**Subject: Beaver Valley Power Station, Unit No. 1 and No. 2
BV-1 Docket No. 50-334, License No. DPR-66
BV-2 Docket No. 50-412, License No. NPF-73
License Amendment Request Nos. 310 and 182**

Subject: Application to Implement the Relaxed Axial Offset Control (RAOC)
and Heat Flux Hot Channel Factor (F_Q) Surveillance Methodologies

~~TYPICAL INDICATED AXIAL FLUX DIFFERENCE~~
~~VERSUS THERMAL POWER AT BOL~~
Typical Axial Flux Differences Limits as a Function of %
RATED THERMAL POWER for RAOC

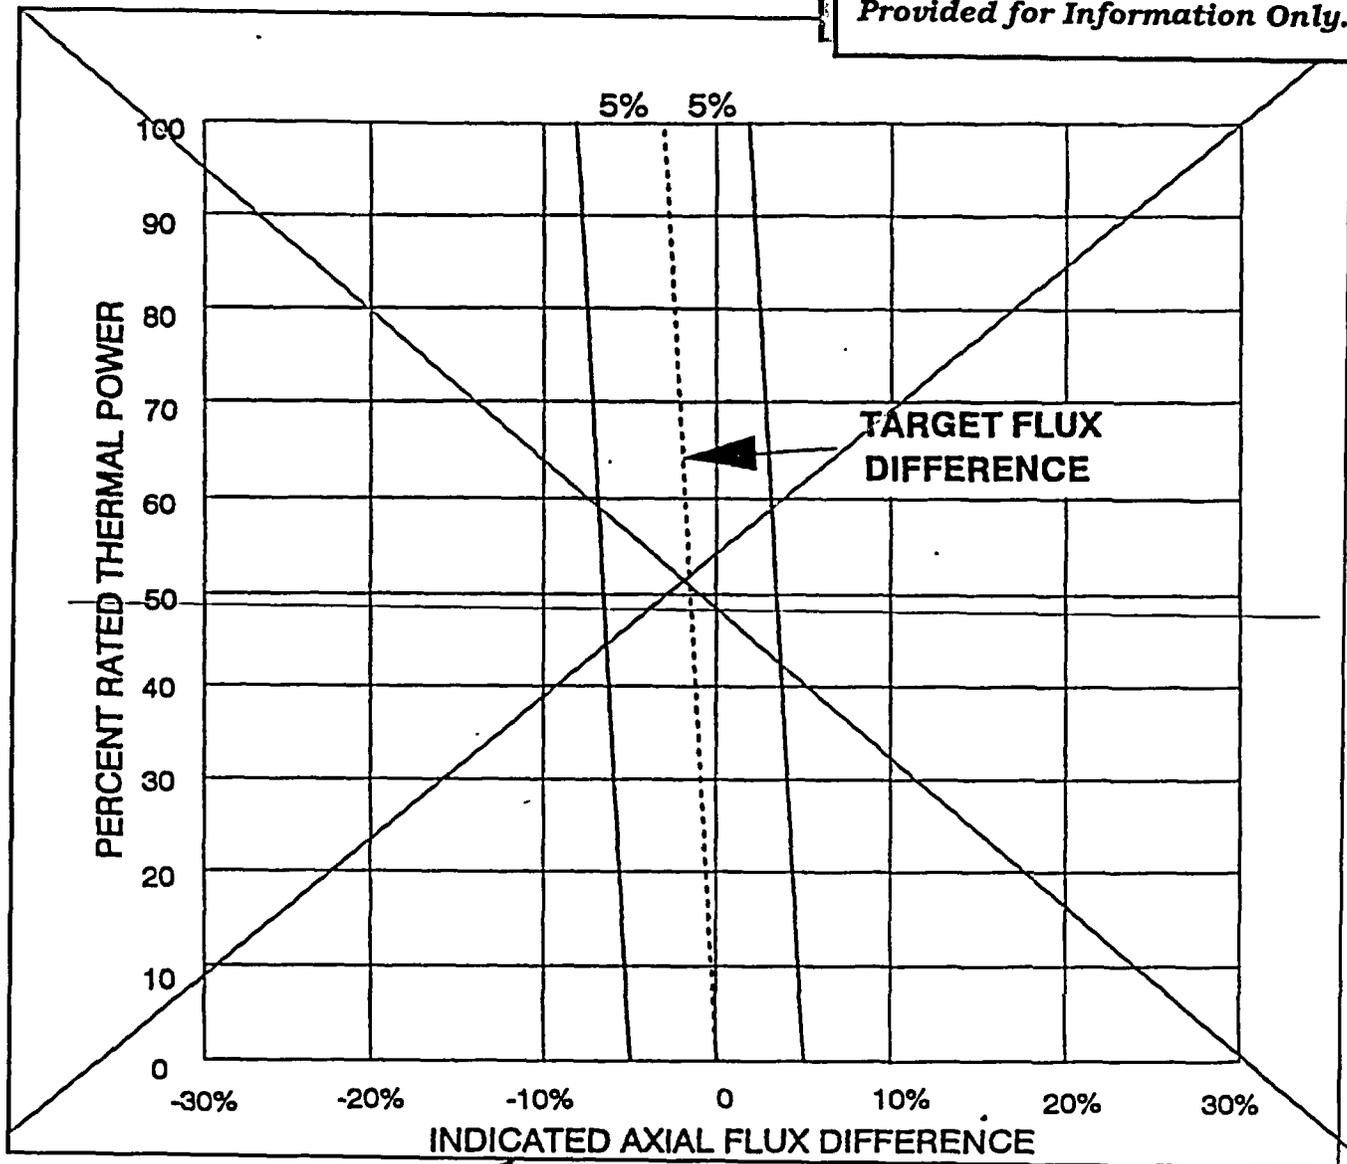
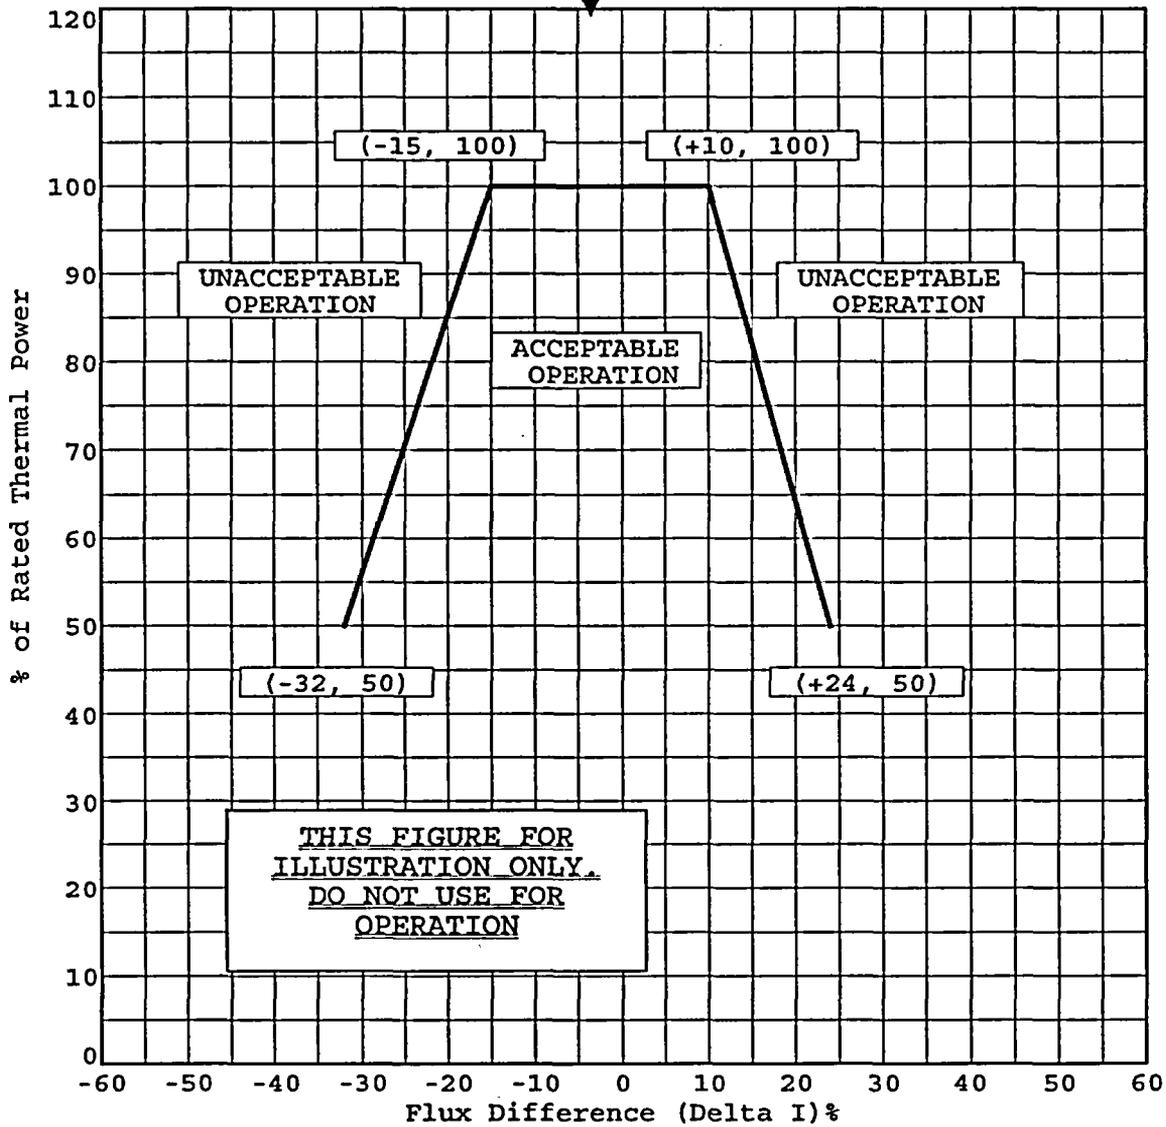
Replace with Insert B.1-1.

Insert B.1-1.

~~FIGURE B 3/4 2-1~~
~~TYPICAL INDICATED AXIAL FLUX DIFFERENCE (AFD)~~
~~VERSUS THERMAL POWER AT BOL~~
Axial Flux Differences Limits as a Function of % RATED
THERMAL POWER for RAOC

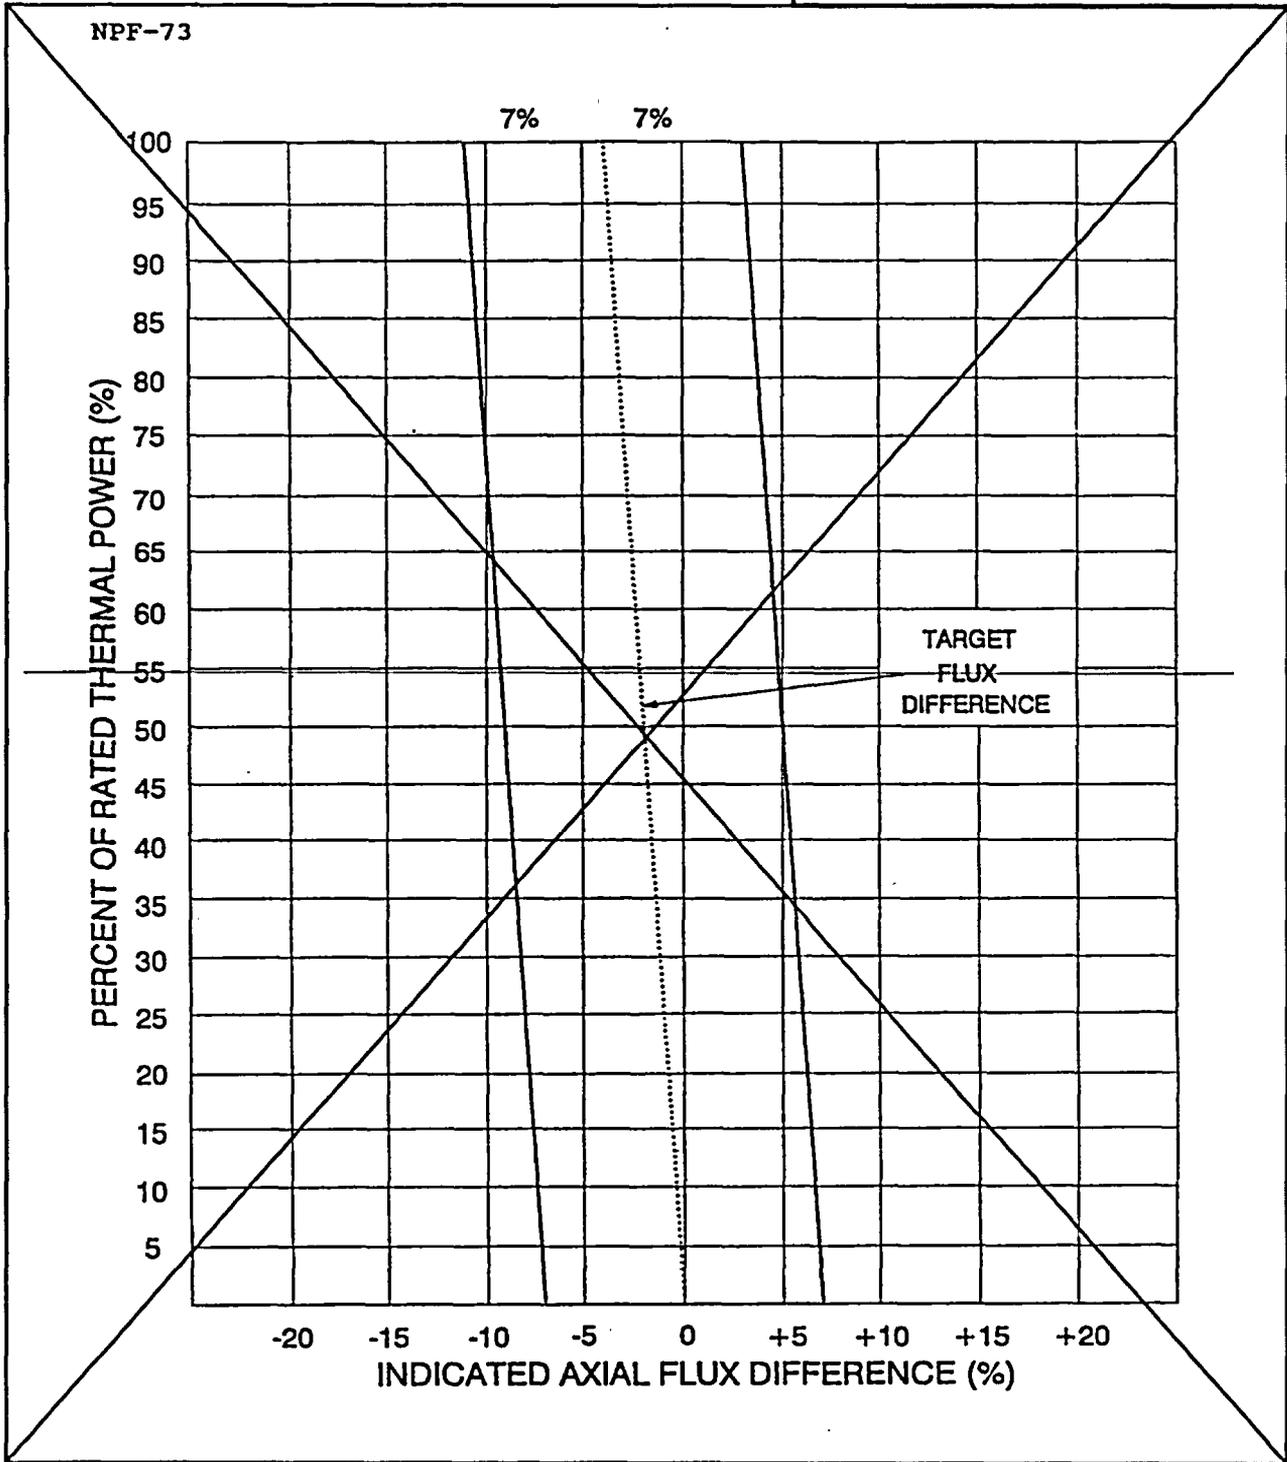
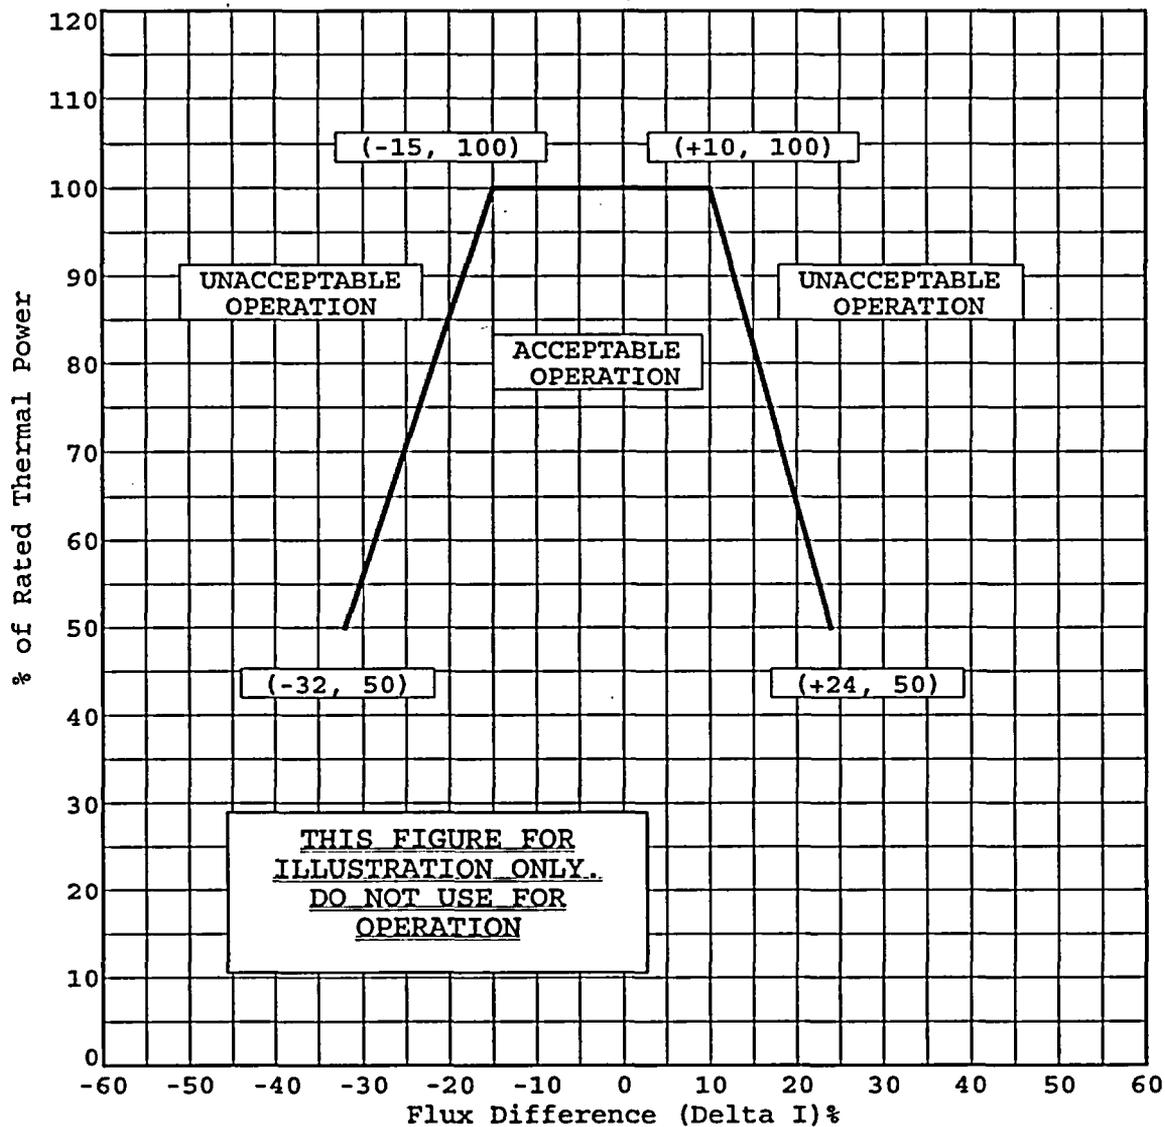
Replace with Insert B.2-1.

Insert B.2-1.

FIGURE 4.1-2
AXIAL FLUX DIFFERENCE LIMITS AS A FUNCTION OF
PERCENT OF RATED THERMAL POWER FOR RAOC

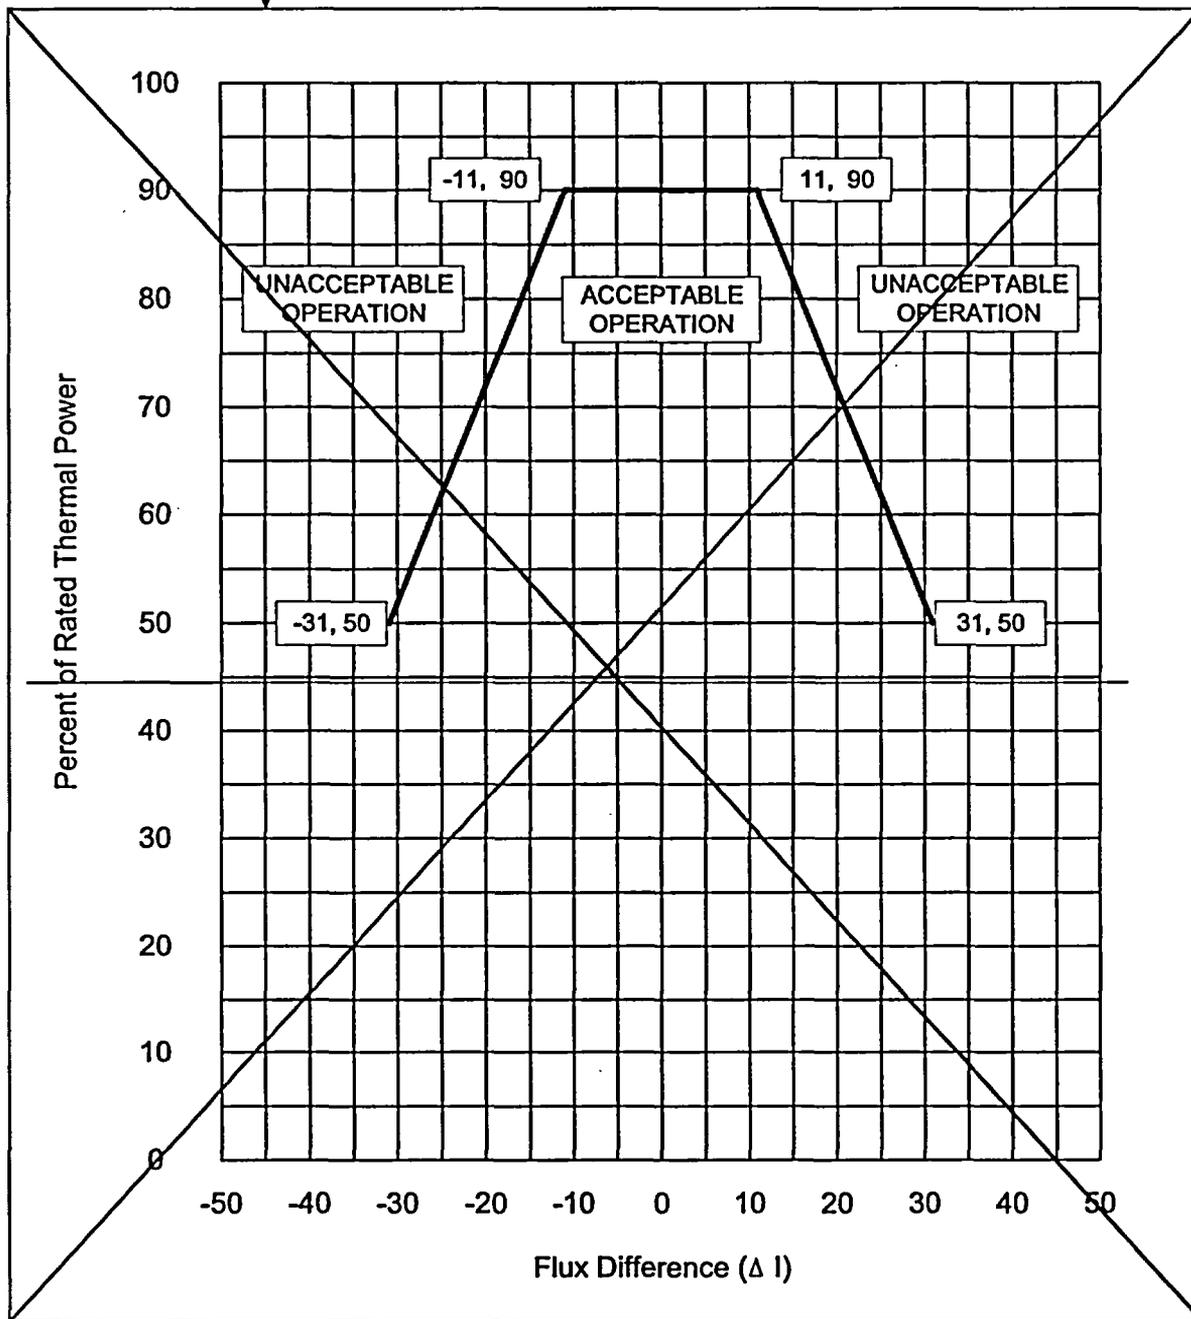
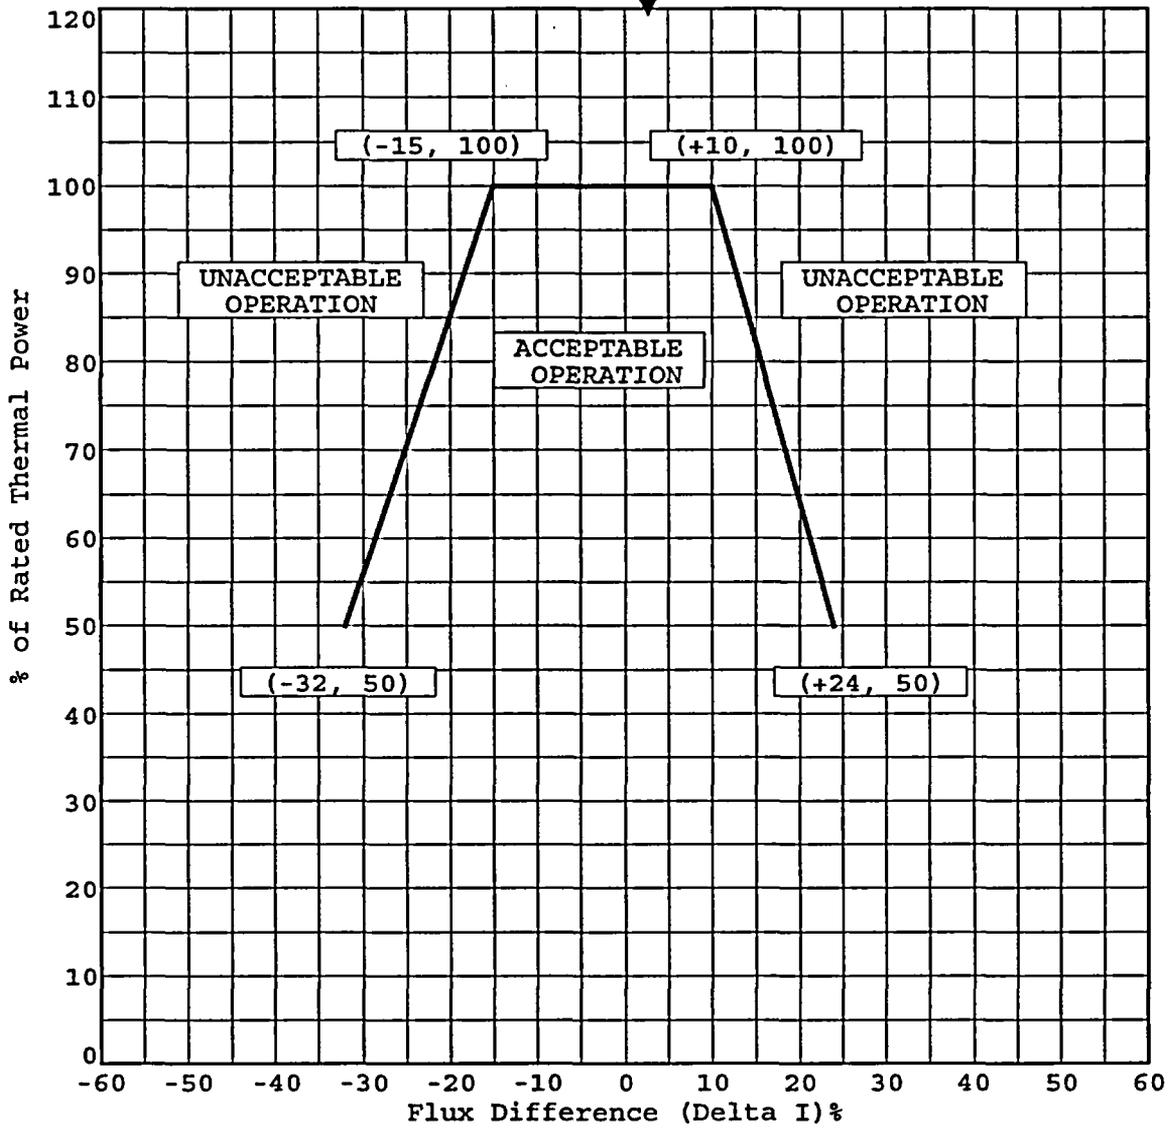
Insert C1-1.
